Re: Change Order No. 1 – Roadway Improvements Project

Re: Diamondhead Roadway Improvements
Change Order No.1

CHANGE ORDER

PROJECT: Roadway Improvements Project

DATE	10/01/2019
SCALE	1"=30'
SHEET NO.	45

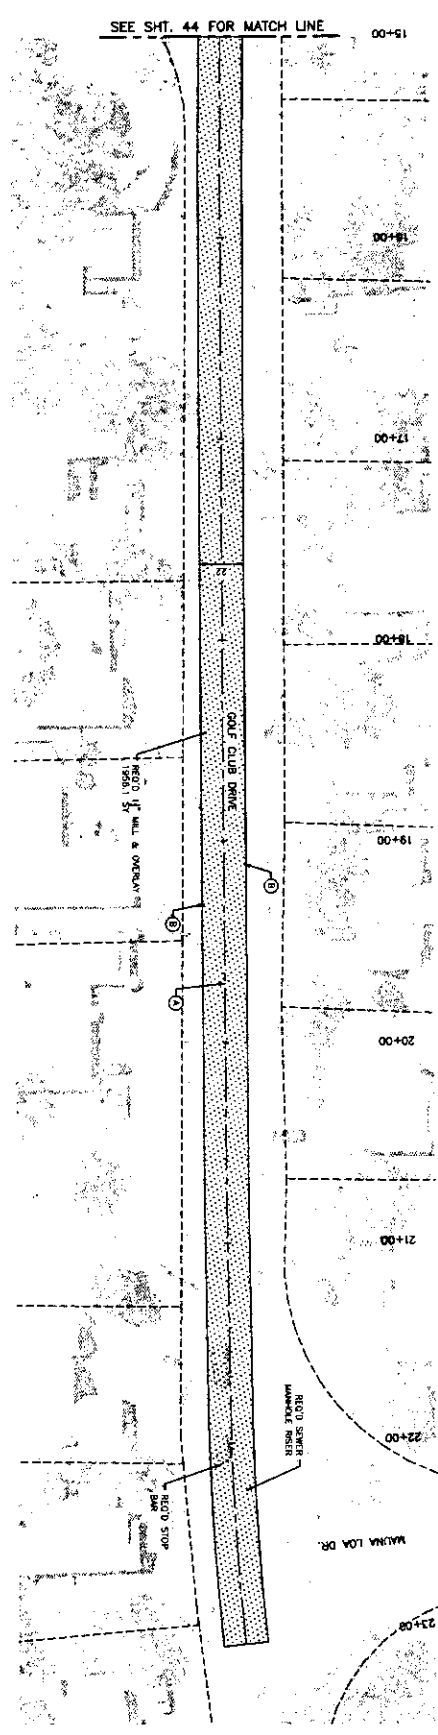
Description: To mill and overlay an additional 827 linear feet of Golf Club Drive to Mauna Loa Drive. See attached Plan Sheet 45. To mill and overlay approximately 697 linear feet of Golf Club Drive from Highpoint Drive to Moanalua Way. See attached Plan Sheet 46.
